addendum

No.	02	**Project:**	WCFPD Station 1
Date:	September 19, 2025	**Project No:**	025-2125

A101

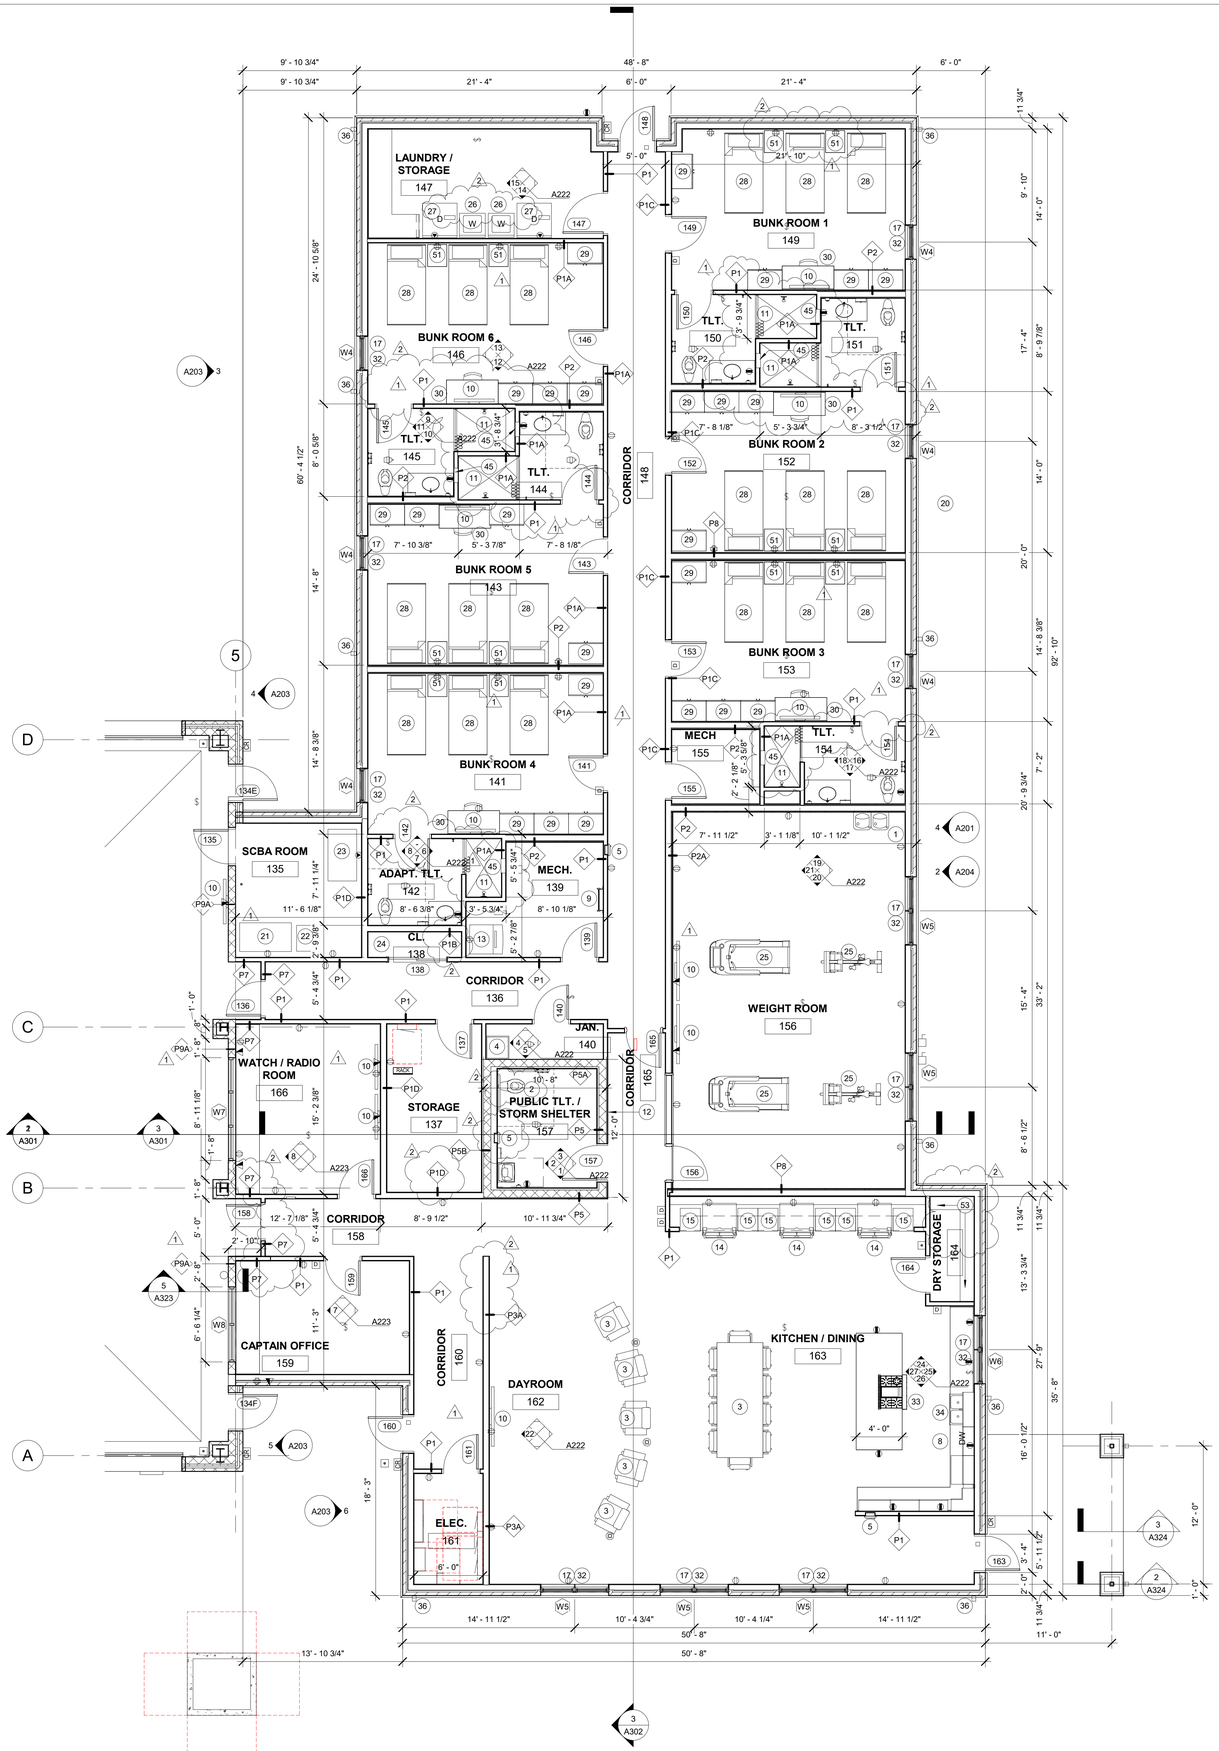
1) Sheet G001 – TITLE SHEET WITH CODE REVIEW
   a. REVISE the sheet index to include new Sheet M301.
2) Sheet A101 – PARTIAL FLOOR PLAN – WEST.
   a. REVISE dimensions at north offices.
   b. ADD Floor Plan Keyed Notes 53 and 54.

c. REVISE Keyed Note 45.
d. ADDED / REMOVED Keyed notes from plan.
e. ADD shower curtain and rod at all shower locations.
f. REMOVE (1) TV from Dayroom 162.

1 A121 REFLECTED CEILING PLAN - WEST
3/16" = 1'-0"

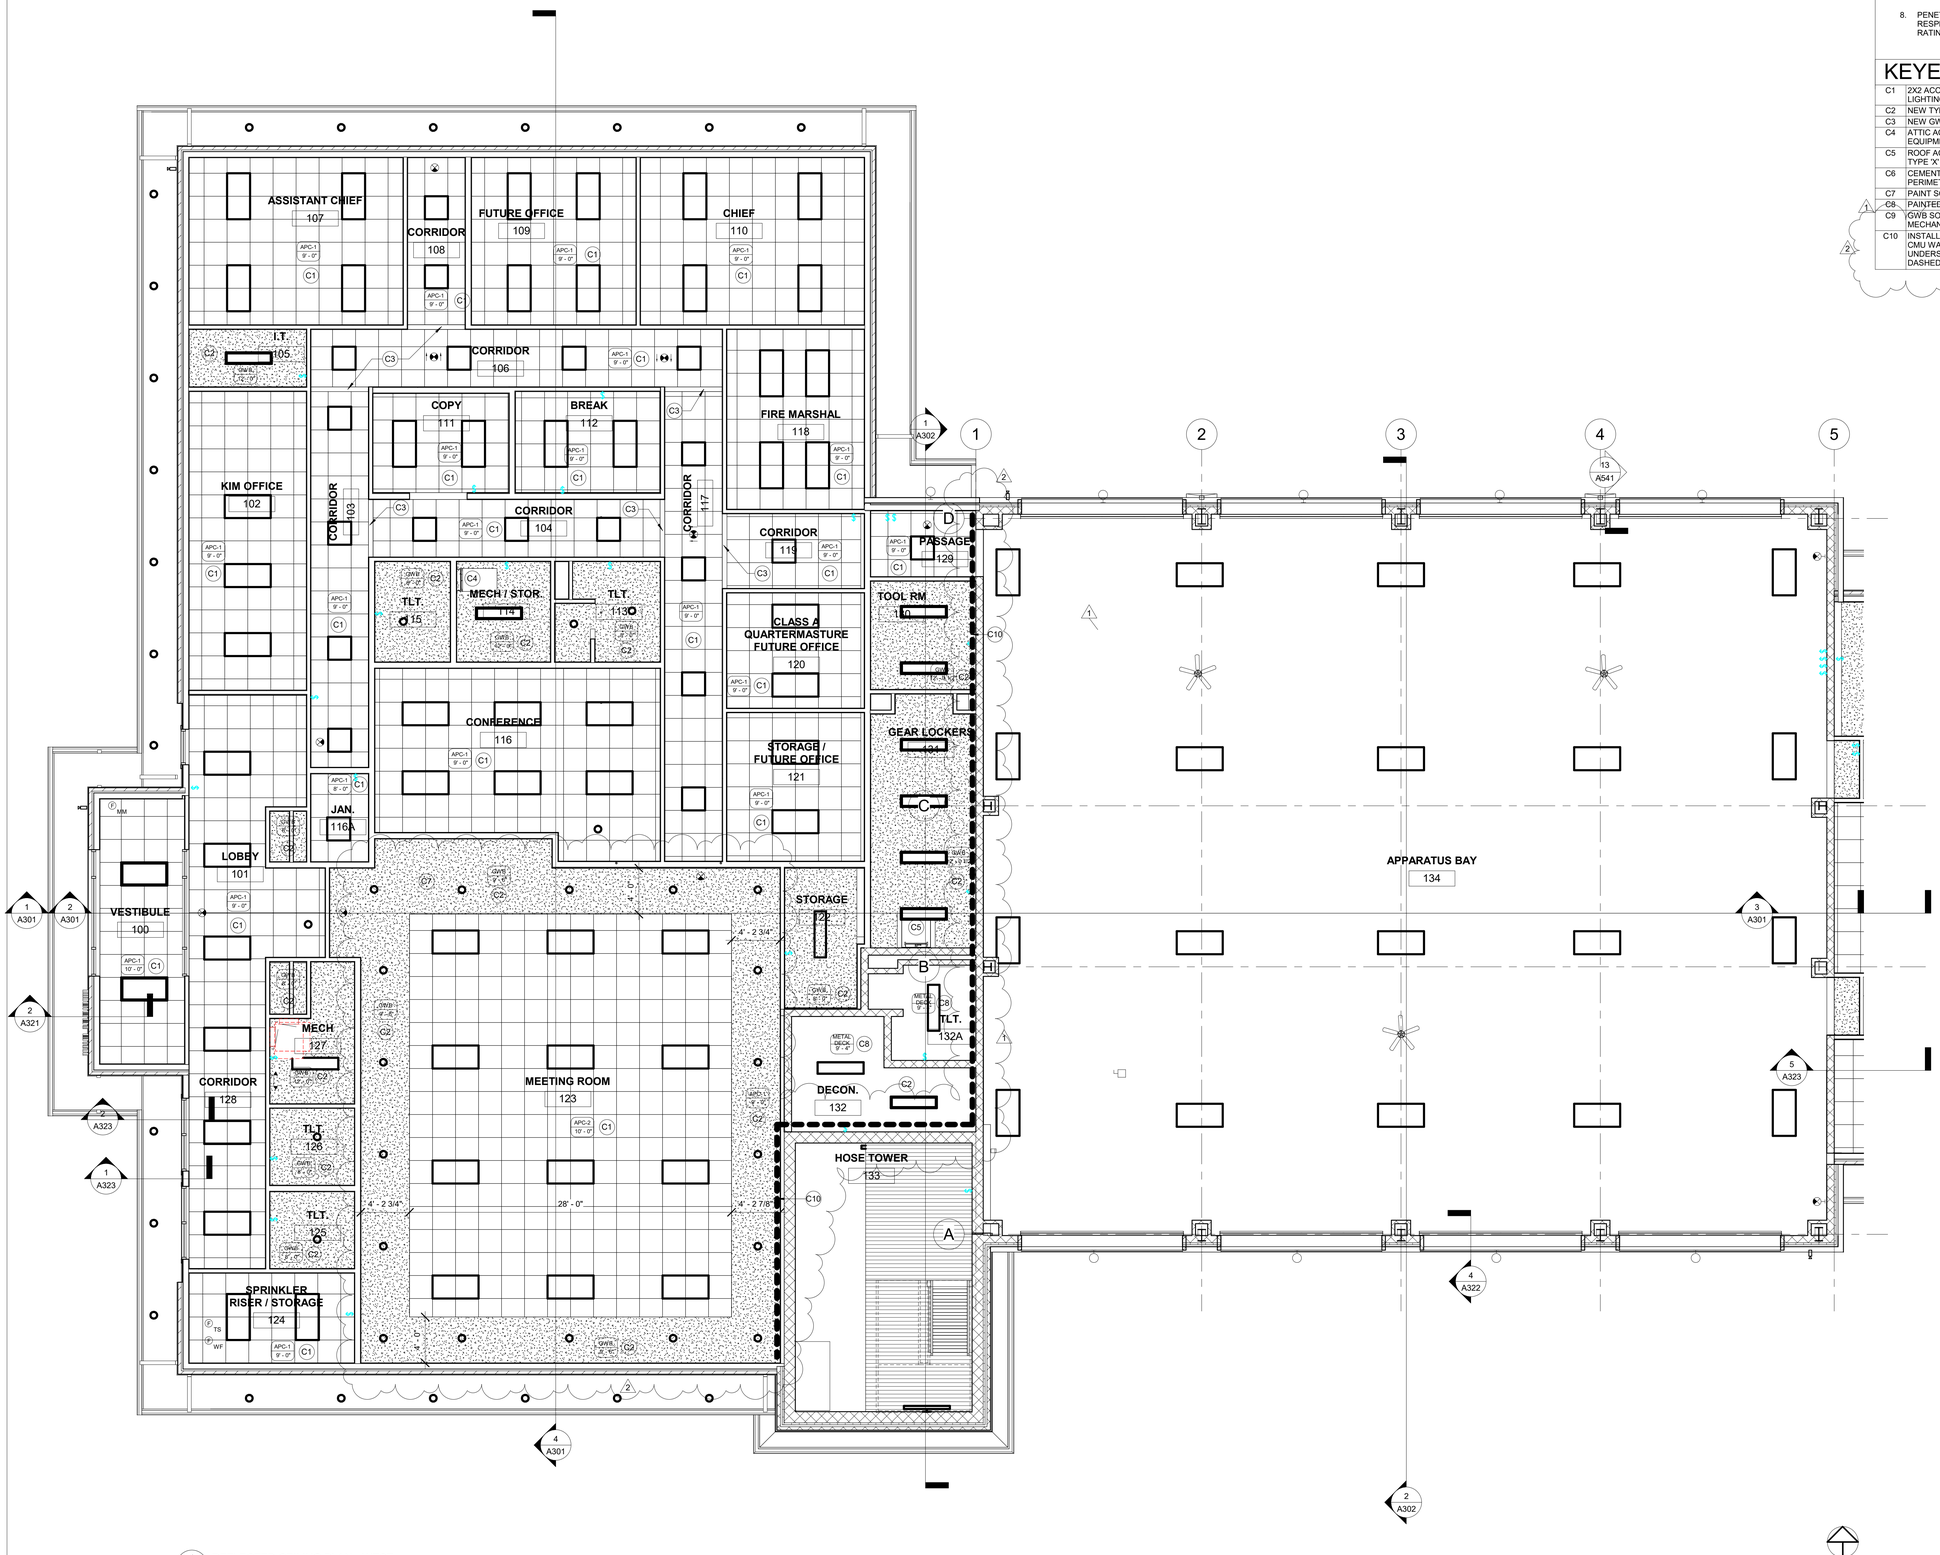
g. REMOVE the TV on the North end of the DAY Room wall.
4) Sheet A121 – PARTIAL REFLECTED CEILING PLAN – WEST
   a. REVISE the height of the Meeting Room 123 acoustic tile ceiling to 10'-0" and the height of the perimeter soffits to 9'-6".

b. ADD Keyed Note C10 regarding attic insulation. ADD dashed line on plan indicating location of insulation on face of CMU walls.
5) Sheet A122 – PARTIAL REFLECTED CEILING PLAN – WEST

1 A122 REFLECTED CEILING PLAN - EAST
3/16" = 1'-0"

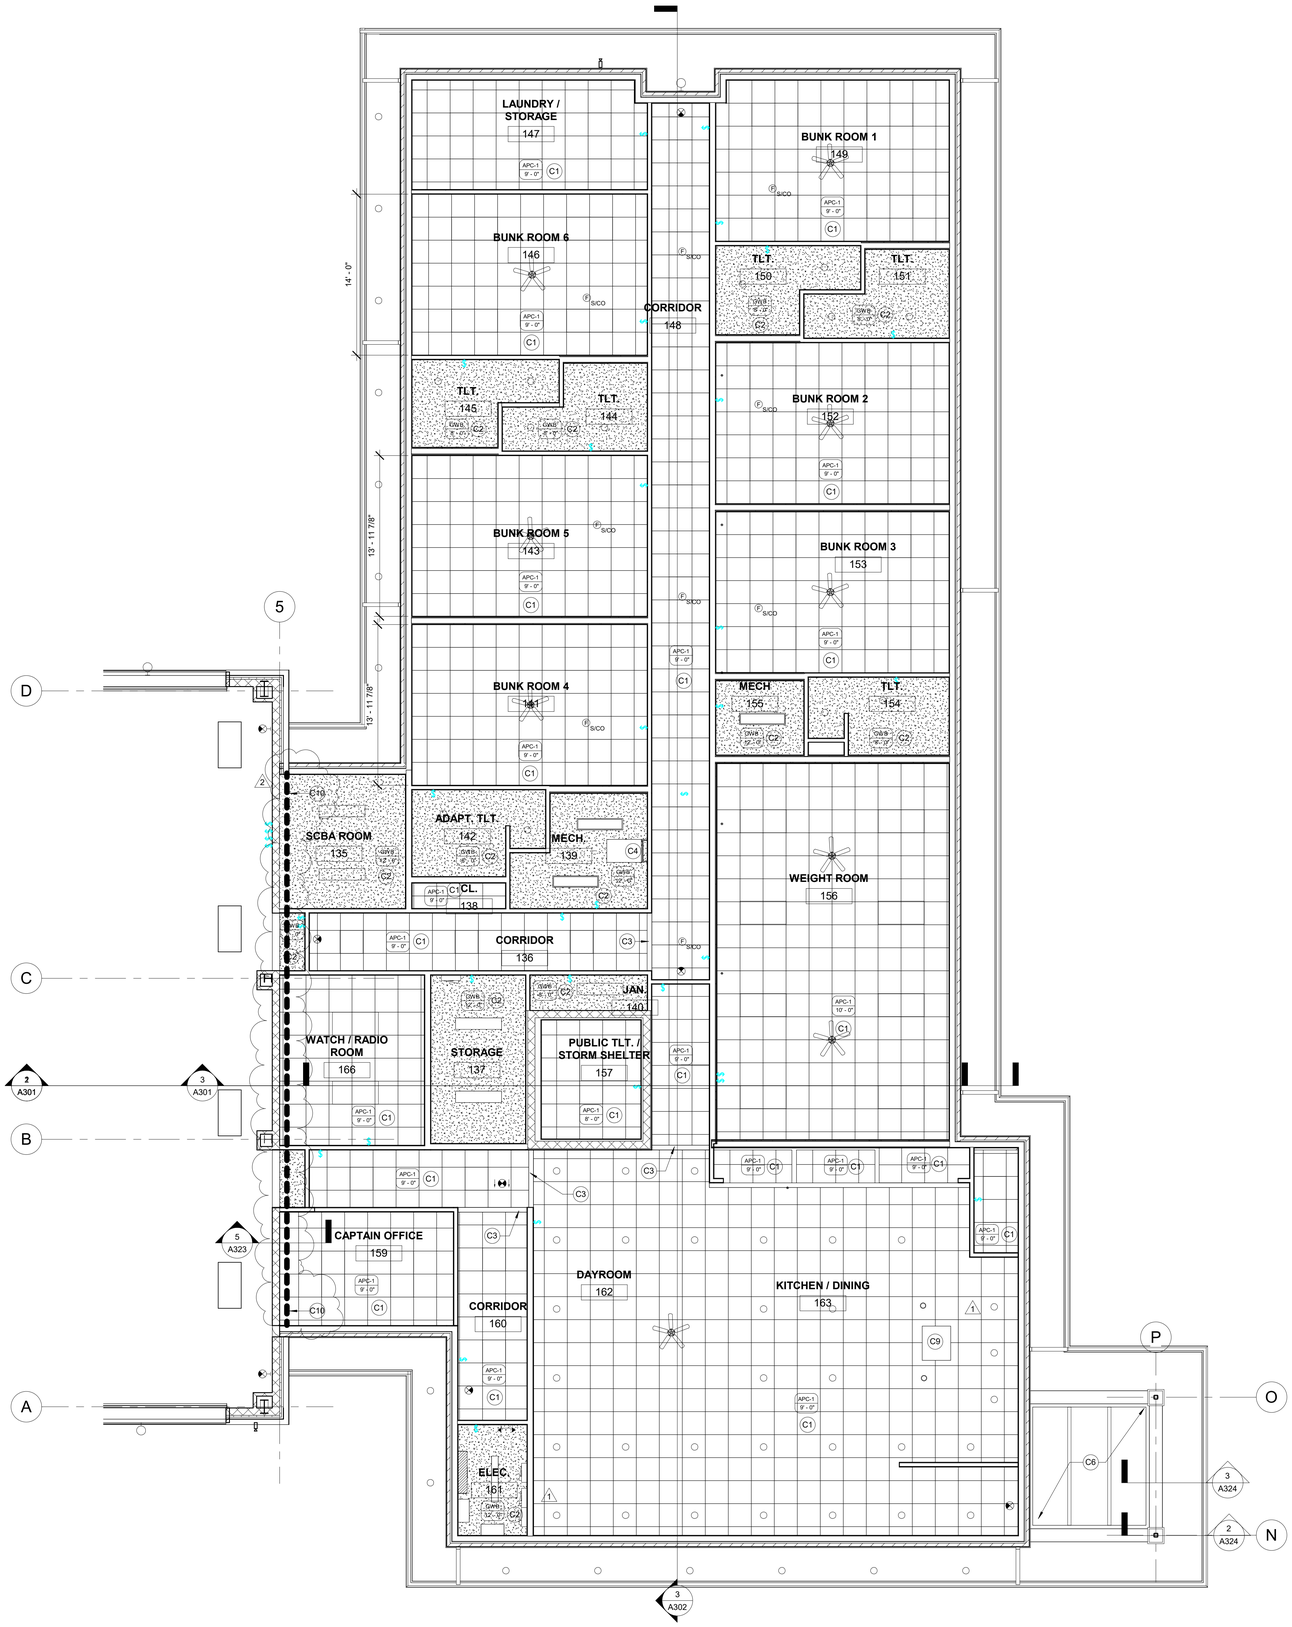
a. ADD Keyed Note C10 regarding attic insulation. ADD dashed line on plan indicating location of insulation on face of CMU walls.
6) Sheet A141 – PARTIAL ROOF PLAN – WEST

1 ROOF PLAN - WEST
A141 3/16" = 1'-0"

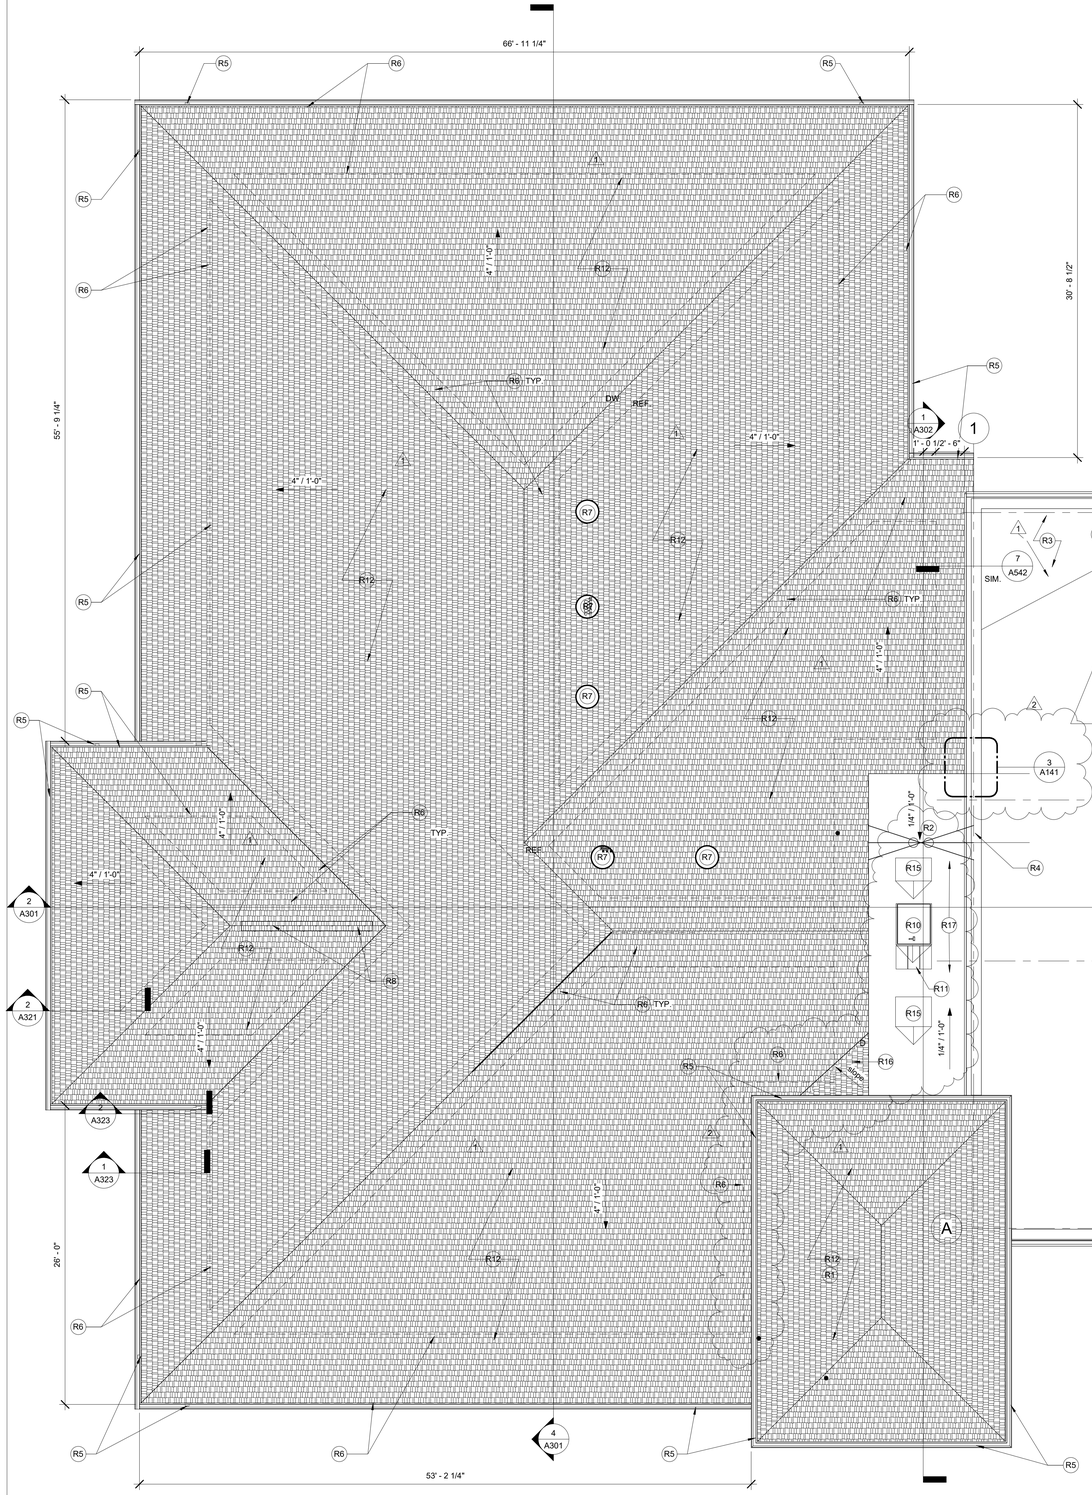
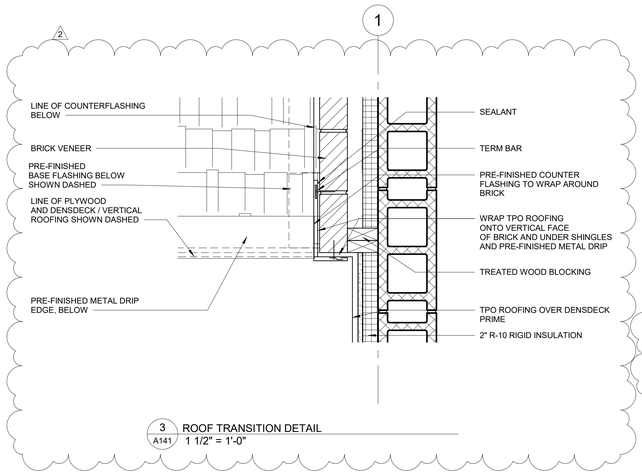
a. ADD additional Ice and water guard locations.
   b. ADD Keyed Notes R13, R14, R15, R16, R17.
   c. ADD roof top mechanical equipment and note.
   d. ADD detail 3/A141 and reference to detail on roof plan.
